To: Members of Dublin City Council

Re: Ordinance 03-16 – Rezoning approximately 30 acres, located on the east side of Perimeter Loop Drive, north of US 33/SR 161, south of Perimeter Drive and Venture Drive from PUD, Planned Unit Development District (existing MAG plan) and PCD, Planned Commerce District (Perimeter Center, Subarea D) to PUD (Midwestern Auto Group PUD) to incorporate approximately 5.4 acres into the MAG PUD to expand the automobile dealership campus to accommodate the construction of a combined showroom for the Jaguar and Land Rover brands, the future demolition of the existing Land Rover showroom, a new showroom for the Porsche brand, and the addition of an elevated showroom addition to the main building for the Lamborghini brand. (Case 15-113Z/PDP)

15-113Z/PDP
 Rezoning/Preliminary Development Plan
 MAG - Porsche/Jaguar/Land Rover
 6335 Perimeter Loop Road

As Approved by the Planning and Zoning Commission January 7, 2016
As Submitted to City Council For Introduction of Ordinance 03-16

Site Plan - Phase I
 SCALE 1" = 80'-0"

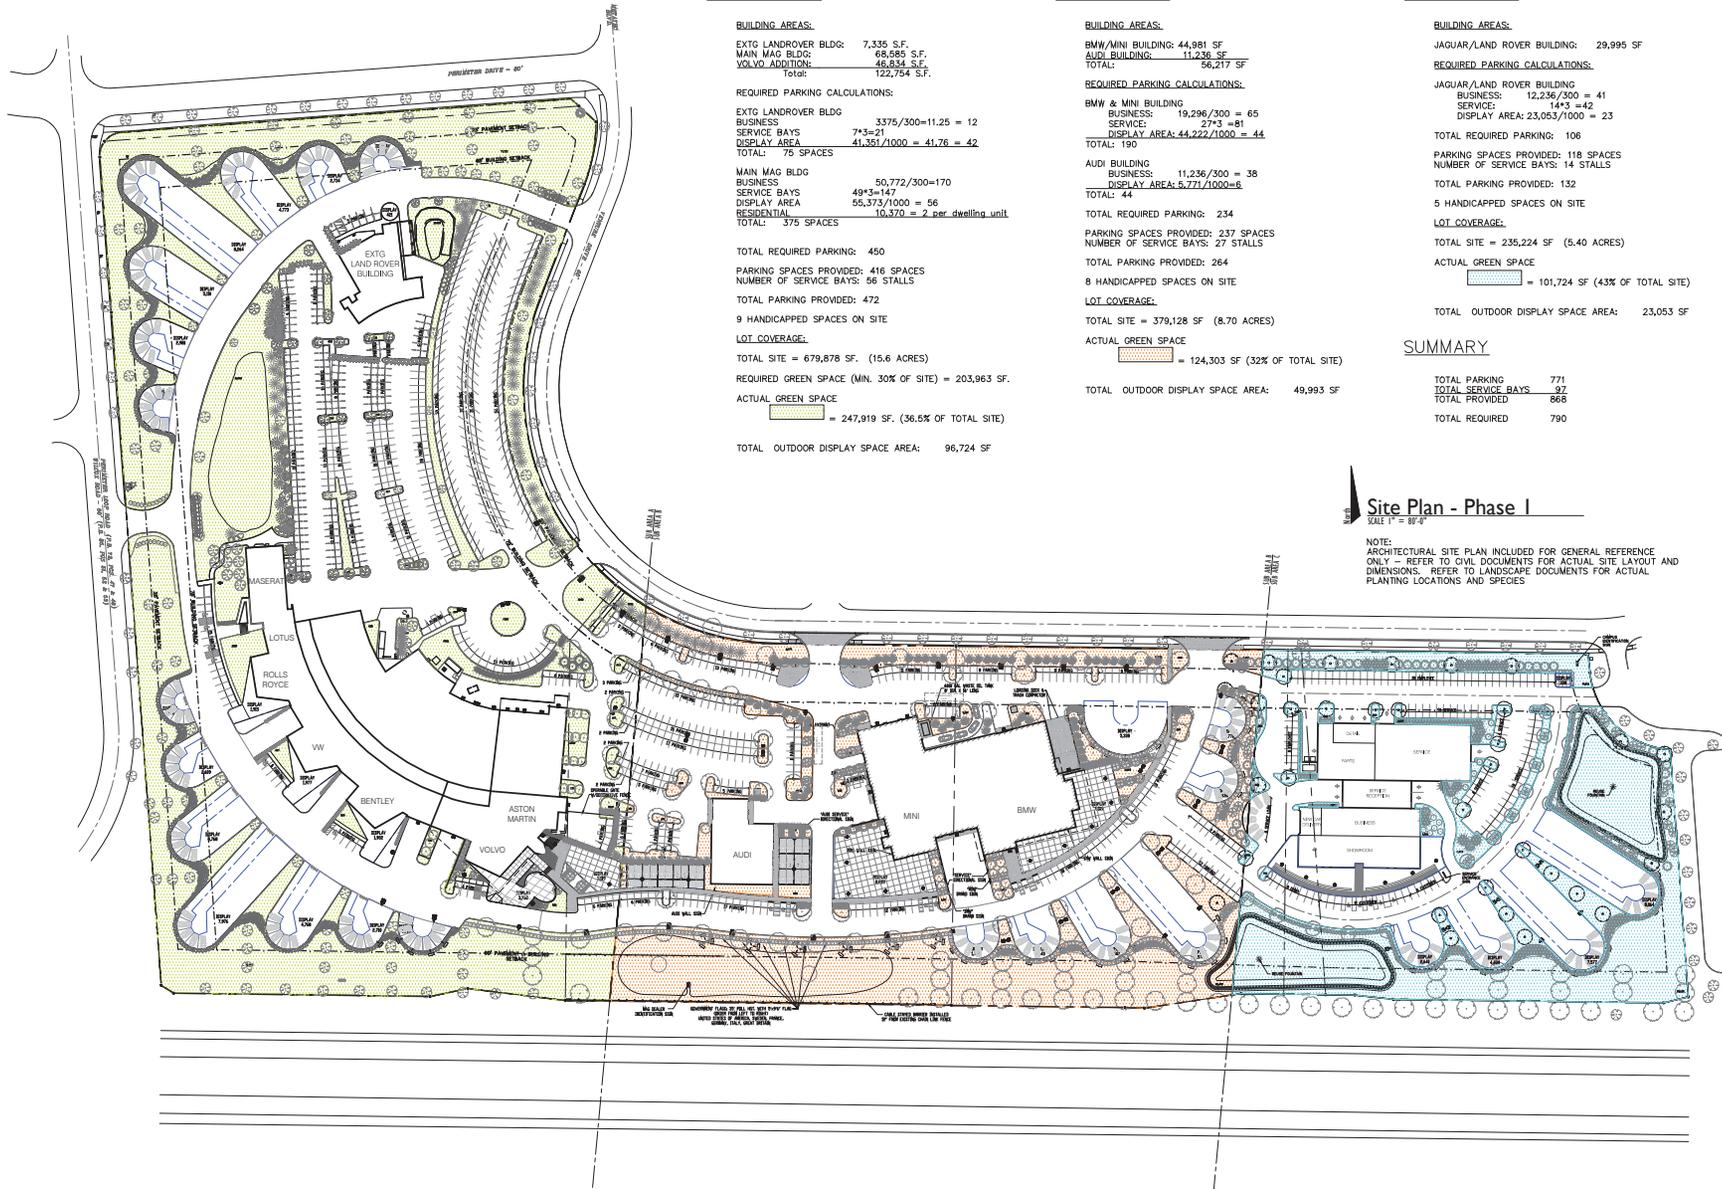
- 4) That the applicant update the proposed plans to accurately indicate the required setbacks along the southern property line;
- 5) That the proposed development text be revised to address the sign allowances in Subarea A to more accurately reflect the sign needs for the single brand building anticipated;

- 10) That the applicant work with staff to provide either additional articulation, landscaping or layout changes for the service drive for the southern elevation of the service area at the final development plan stage, and;

SHEET NUMBER: 4.01

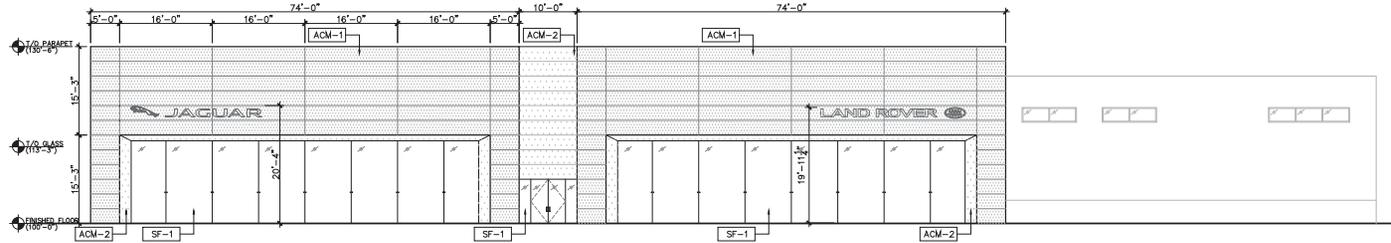
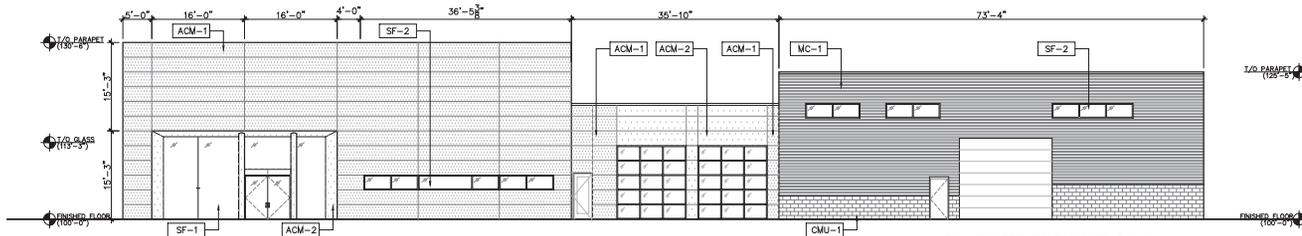
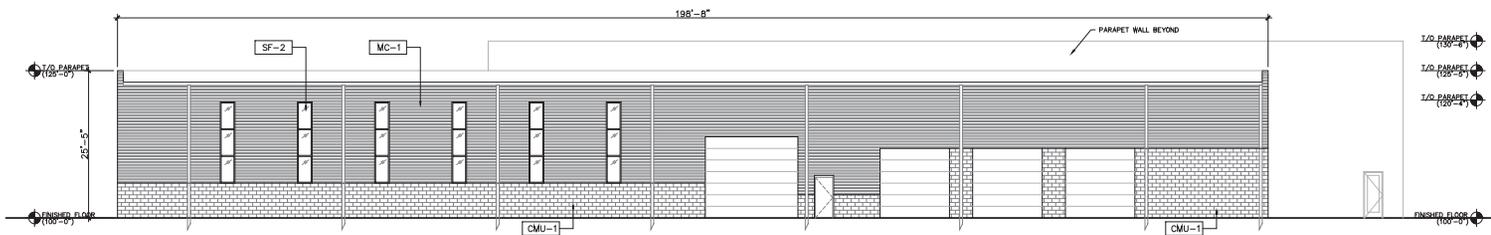
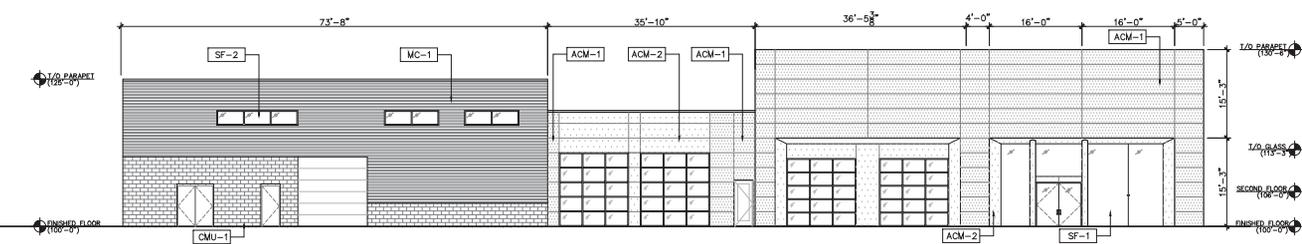
The remaining elevations include CMU, metal and metal cladding as building materials. The changes in materials, use of windows and recesses in the elevations create interesting viewpoints and continue the contemporary look of the campus. The plans show the use of EIFS in the legends but not on the actual elevations.

- 1) That the plans be revised to address building material inconsistencies on sheet 4.01;
- 2) That the applicant work with Planning to identify additional areas for replacement trees, prior to submitting for a building permit;
- 3) That the size of the brand identification sign be reduced to 40 inches; and
- 4) That the applicant revise the application to remove the green building materials from the application and replace the material with a material and color reflecting existing characteristics on campus.

All final details for the building, including colors of materials, will be approved by the Planning and Zoning Commission at the final development plan stage.
